From: sun wo wong <[REDACTED]>
Sent: 2026-07-16 星期四 18:26:56
To: Yan Yan LAM/PLAND <yylam@pland.gov.hk>; tpbpd/PLAND <tpbpd@pland.gov.hk>; Steven Kang Shun MA/PLAND <sksma@pland.gov.hk>
Subject: A/TM-LTY/504
Attachment: 回應 NMCO, DEVB 16-07-2026(1).pdf; 回應 EPD 的擬問 16-07-2026.pdf; 回應 DSD 提問 07-07-2026.pdf; 回應 TD 的擬問.10-07-2026-1.pdf

此電郵文件係取代 13-07-2026 交付貴會的文件

回應 EPD 的擬問

回應 DSD 的擬問

車輛機動模擬圖

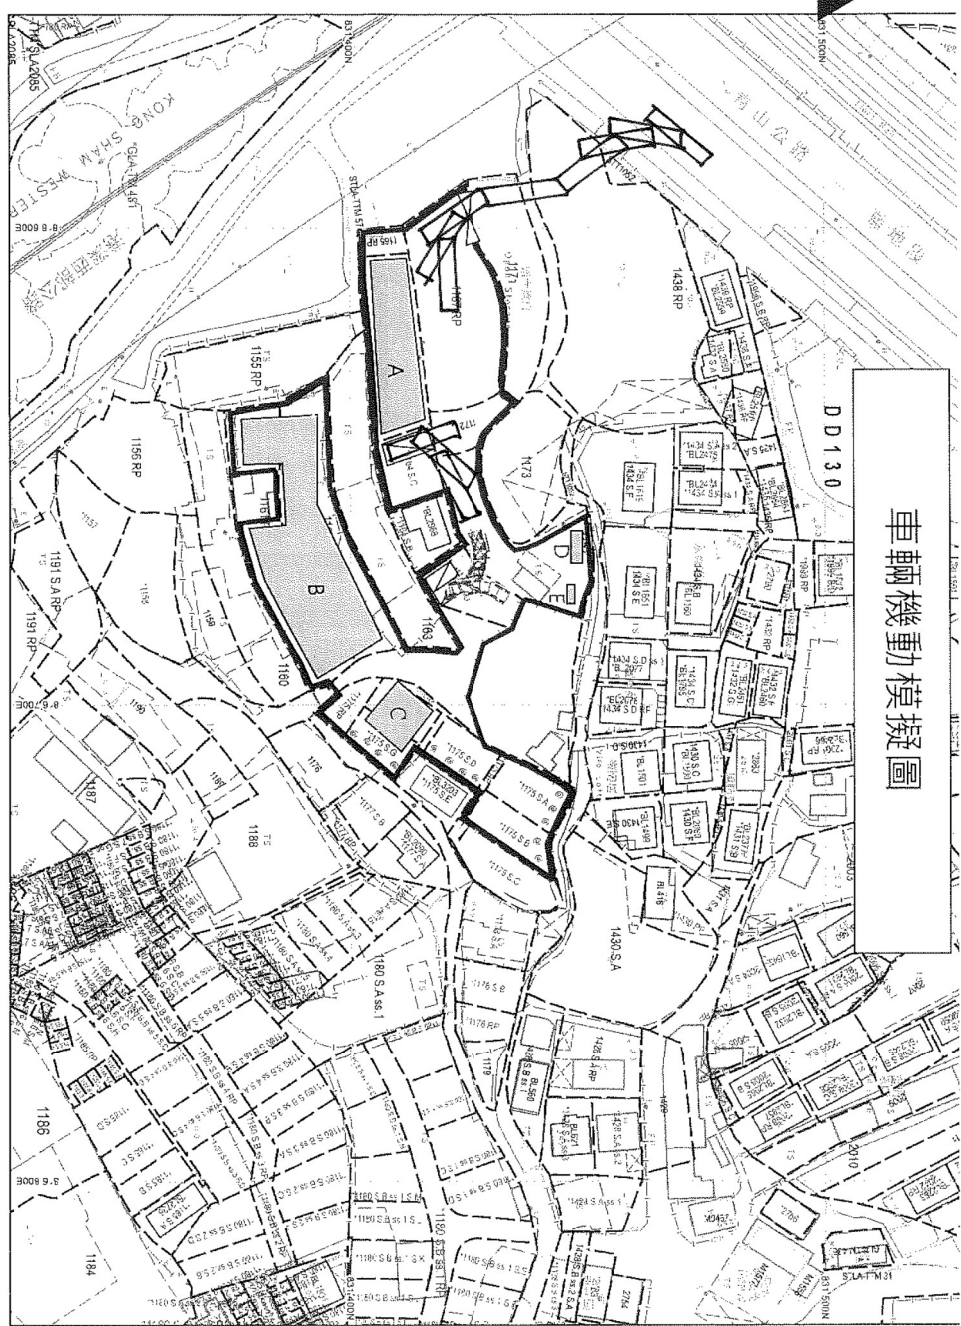
Grateful request the applicant for the following for our consideration please:

extent/area of affected premises in DD 124 Lot 1162sC (part lot / entire lot), and any plan indicating such extent/area;

if such extent/area is smaller than the application site area, the respective justifications for such increase, if any, in land required; and

the relevant details of site search for alternative premises attempted by the applicant (e.g. locations of alternative sites explored; reasons why they are not suitable, etc.).

4. Swept path analysis shall be provided for various vehicle types.
隋函附上車輛機動模擬圖給貴署參考。
5. Sufficient vehicle manoeuvring space should be reserved within the proposed site. Please ensure that no queuing and/or waiting of motor vehicles from the site onto Wong Kong Wai Road, and/or Castle Peak Road – Lam Tei, would occur and no motor vehicles shall be permitted to reverse into and out of the site onto Wong Kong Wai Road, and/or Castle Peak Road – Lam Tei

我等位於DD 124 Lot 1162sC的土地面積1856.6平方米而
我等在田廈路舊址場地只有小小的車路，其他地方全部存放建築機械及配件，
和維修場，而是次申請地點有 1 大段行車通道，及設有走火通道，占用了不小
地方，實際可用的土地和舊有場地差不多，最主要舊場地存放機械太過緊密，
不方便營運，而新地點地方多一點在展銷其間每部機械都能展視給客人查驗，
而舊有場地，餘地不足令至我等不能將全部機械展視給客人揀選，而時次搬遷
雖然政府給與補貼，但我等都有損失，我等同意政府因發展而收回我等土地，
有關我等是次申請的面積約為4750平方米，但我等實際可用的土地只有1418平
方米，主要原因申請位置地型全部為不規則地帶扣除倉庫用地餘下的地方需用
作EVA(消防通道及行車通道)，因應環境保護署的要求，構築物C須要需要在
LOT1175各餘段由原先的構築物625平方米改為現時的100平方米，承餘的土地
只能用作消防及走火通道，及種植多棵樹木作為美化環境用途。在新的布局圖
清楚列明我等實際可用的地地只有1418平方米 與舊場地1856.6平方米還減少
400多平方米，請看附件 (車輛機動模擬圖)希望北都辦能諒解和給與批准是次申請。

雨水排放建議圖

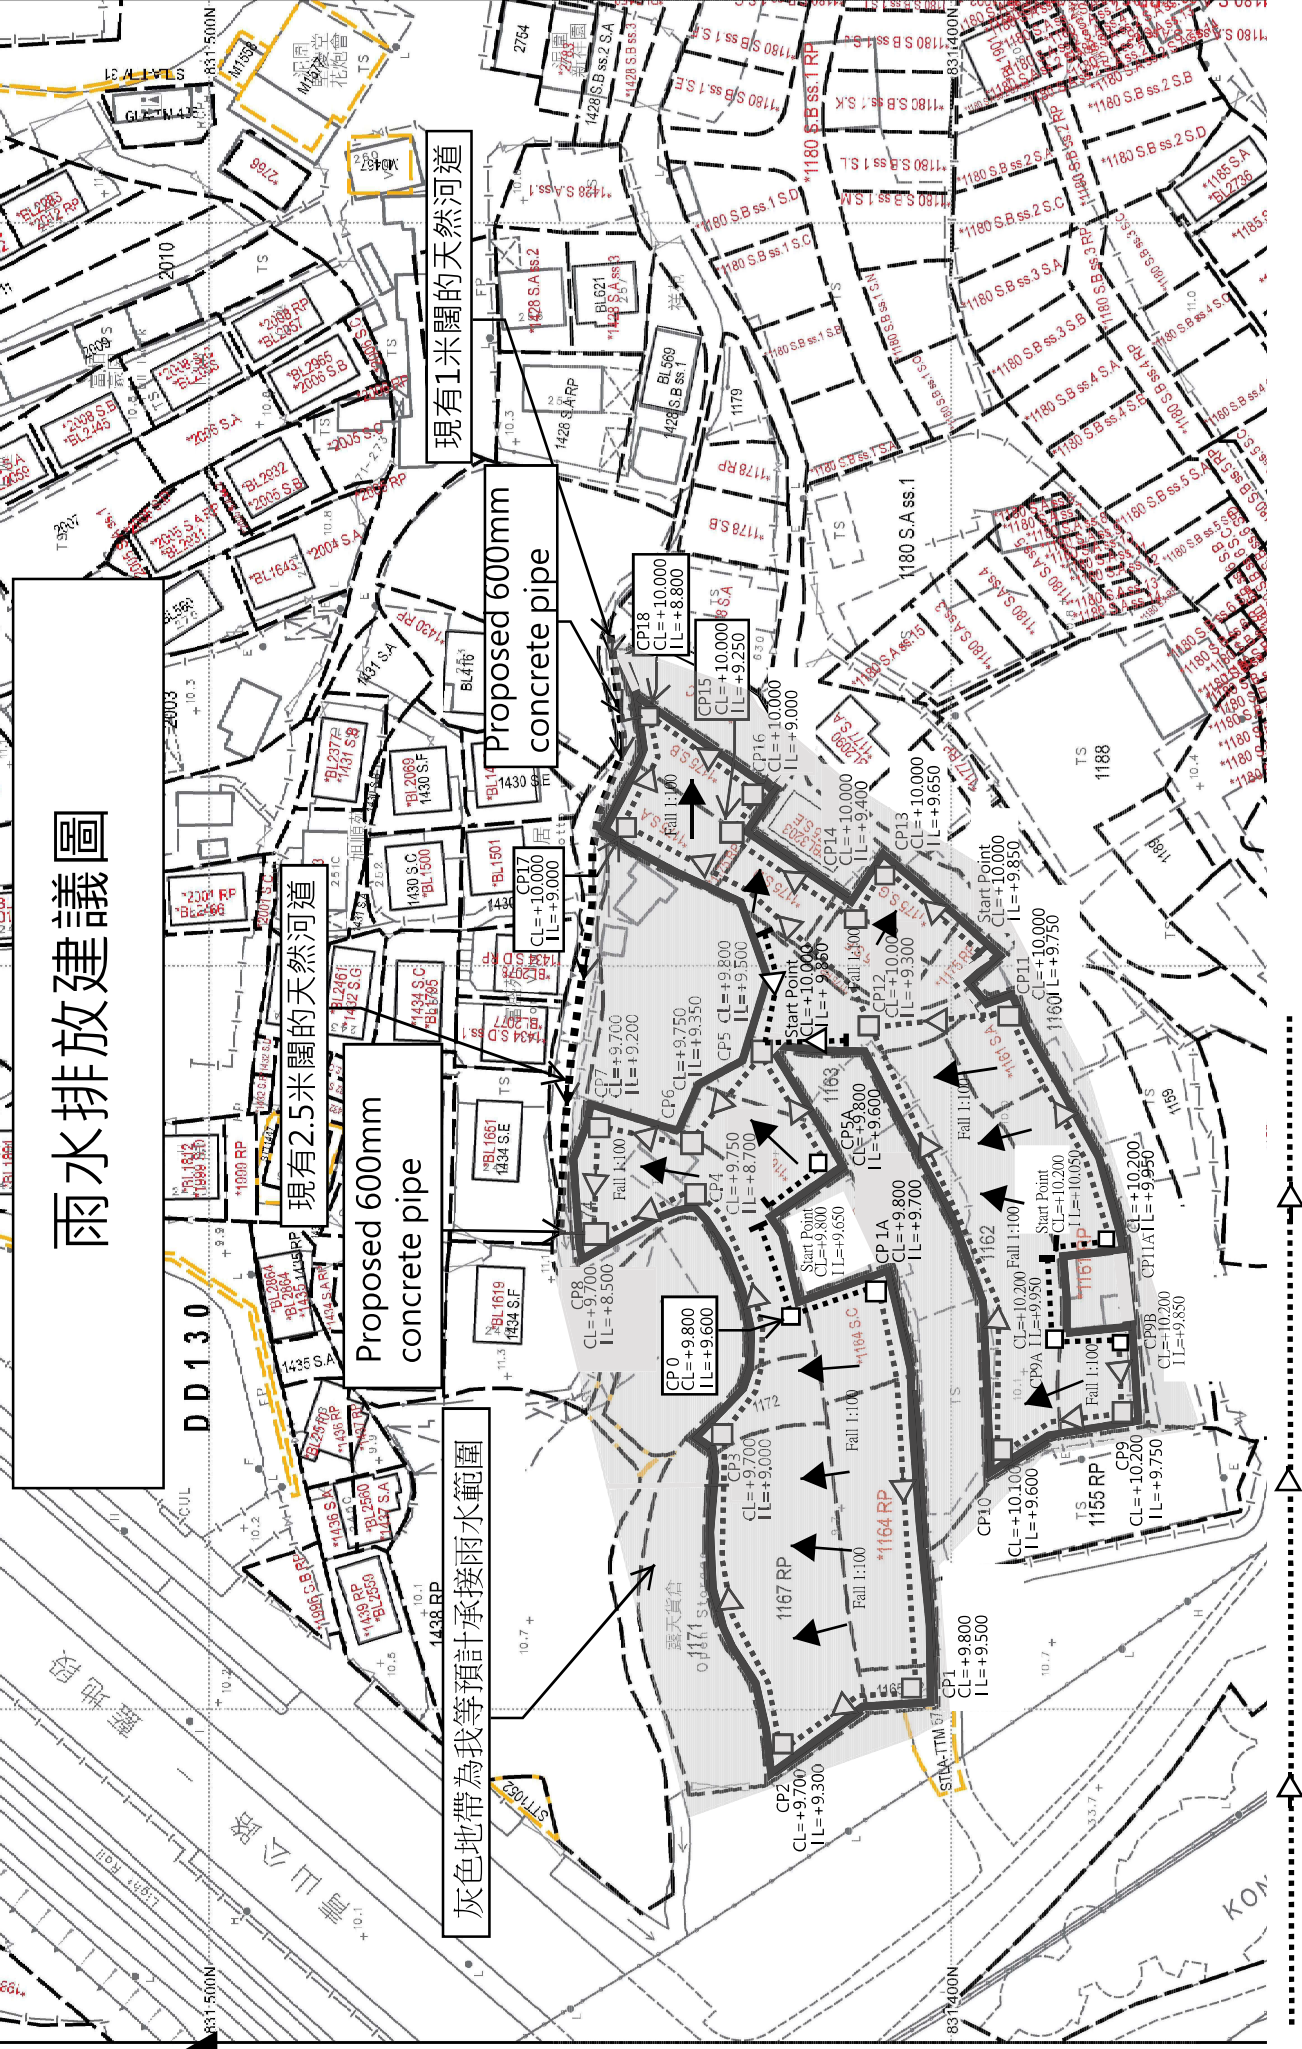
1. Response to Comments (RtC) item (c) refers, our comment has not yet been addressed. Please provide photo records of the existing "1m wide watercourse" and "2.5m wide watercourse" to demonstrate their presence, sizes and existing conditions.相片隨後附上
2. RtC item (l) refers. The applicant should be reminded that this general comment was referring to stormwater drainage, not sewage.已更新雨水排放建議圖
3. It seems there were two proposed catchpits located at the upstream of proposed CP1, while their cover levels (C.L.) and invert levels (I.L.) were missing. Please provide. 已更新雨水排放建議圖
